## **CONSTRUCTION SUMMARY**

## **Kingsmen (Thames) Inc. / Havelock Corners (Kingsmen)**

## Lot/Unit: 75 Phase/Building: 4A Model/Floor Plan: Louis (4203) Elev B 4 Bed - 4+1 Bath

## PART. GROUND FLOOR EL. B

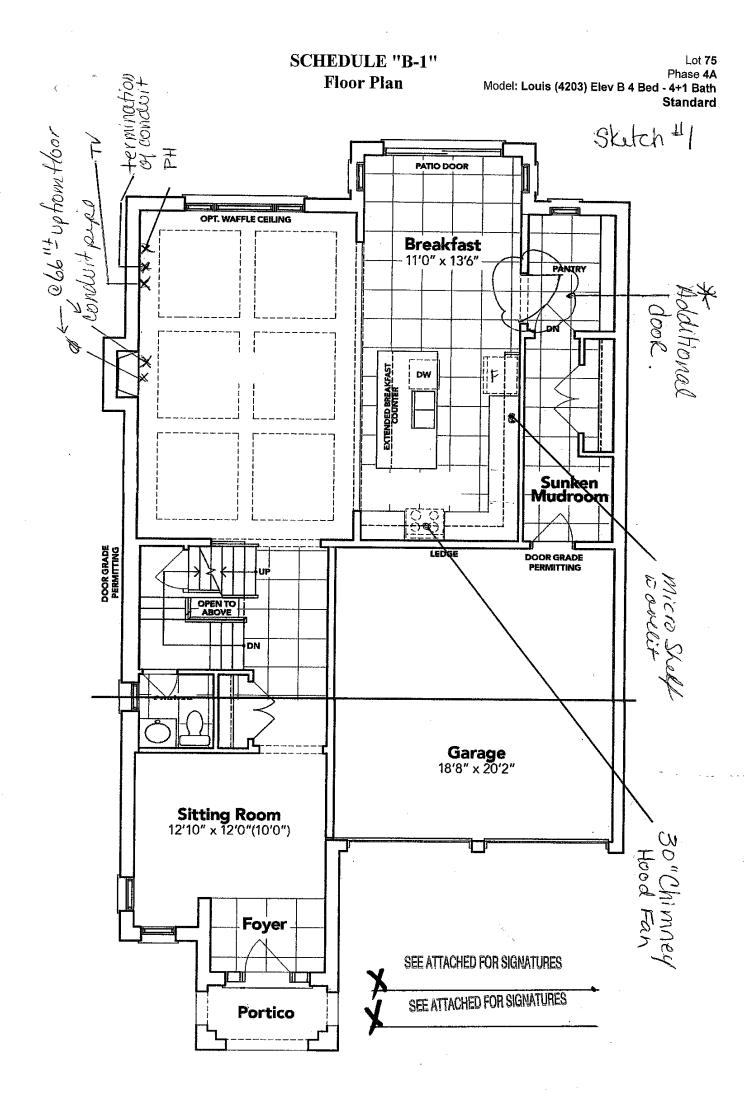
Inv. <b>4577</b>	<b>1</b> - Accomodate for a future 30" chimney hood fan in the kitchen.	
Line 58361	Note: Chimney hood fan is sold sep.	
26Mar20 / 27Mar20

Inv. <b>4577</b>	1 - To supply & install aMICROWAVE CABINET WITH SHELF - OPENING 24 INCHES WIDE X 13 3/4 INCHES HIGH - PURCHASER MUST SUPPLY SPECS in the kitchen see sketch # 1	
Line 58372	Note: Electrical outlet on a sep. curcuit is sold sep.	
26Mar20 / 27Mar20

Electrical		
Inv. <b>4577</b>	1 - To supply & install a receptacle on a sep. curcuit for the microwave shelft	
Line 58373	Note: Microwave shelf is sold sep.	
26Mar20 / 27Mar20		
Inv. <b>4577</b>	1 - To supply & install the CYCLONE 30" chimney hood fan in stainless steel Model #	
	SCB50030 in lieu of the std. 30" stainless steel hood fan see spec's	
Line 58360	Note:	
26Mar20 / 27Mar20		
Inv. <b>4577</b>	1 - To supply & install the standard T.V. rough in in the great room and master bedroom see	
	sketch # 1 & # 2	
Line 58363	Note:	
26Mar20 / 27Mar20		
Inv. <b>4577</b>	1 - To supply & install the standard Phone rough in in the great room, master bedroom and	
	Bedroom # 2 see sektch # 1 & # 2	
Line 58364	Note:	
26Mar20 / 27Mar20		
Inv. <b>4577</b>	1 - To supply & install a receptacle at approx. 66 " + - up from the floor centered + - to the F/P	
	mantle and terminated next to + - the upgraded conduit pipe see sketch # 1

Line 58365	Note: This is for a future wall mount T.V.	
26Mar20 / 27Mar20		
Inv. <b>4577</b>	1 - To supply & install a conduit pipe at approx. 66 " + - up from the floor centered + - to the	
	F/P mantle and terminated next to + - the standard T.V. rough in the great room see sketch

Inv. <b>4577</b>	1 - To supply & install a door between the breakfast area and pantry area see sketch # 1	
Line 58369	Note:	
26Mar20 / 27Mar20

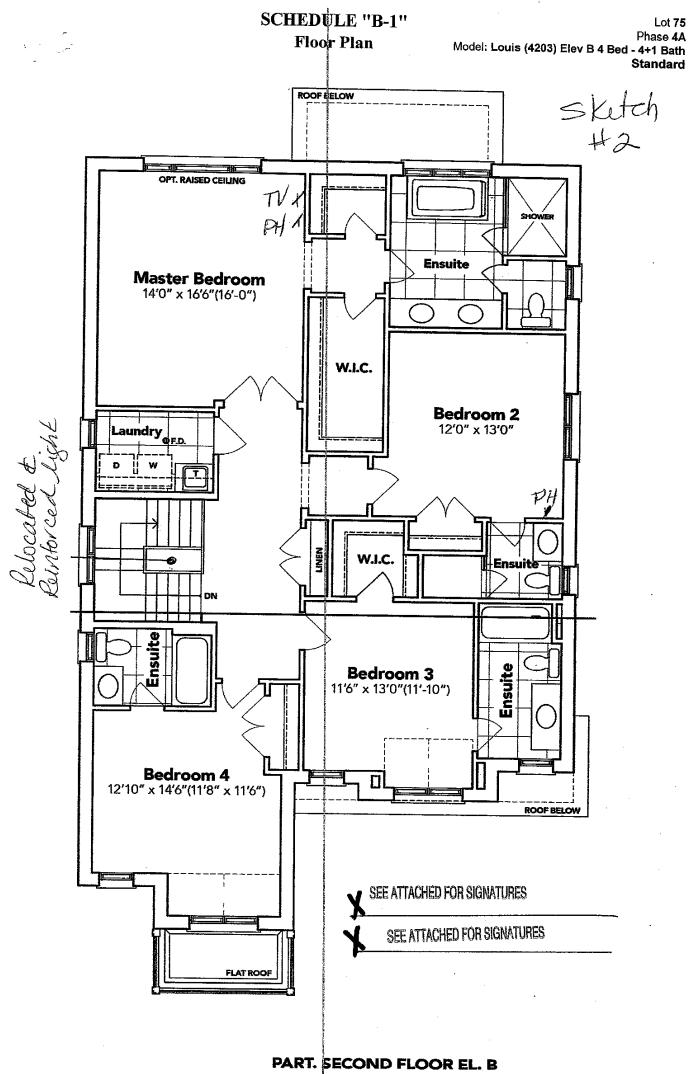
#1	
Line 58366	Note: This is for a future wall mount T.V.	
26Mar20 / 27Mar20		
Inv. <b>4577</b>	1 - Relocate the std. ceiling light from the upper stair landing to the O.T.B. on the second	
	floor see sketch # 2	
Line 58367	Note:	
26Mar20 / 27Mar20		
Inv. <b>4577</b>	1 - Reinforce the relocated light at the O.T.B. area on the second floor see sketch # 2	
Line 58368	Note:	
26Mar20 / 27Mar20
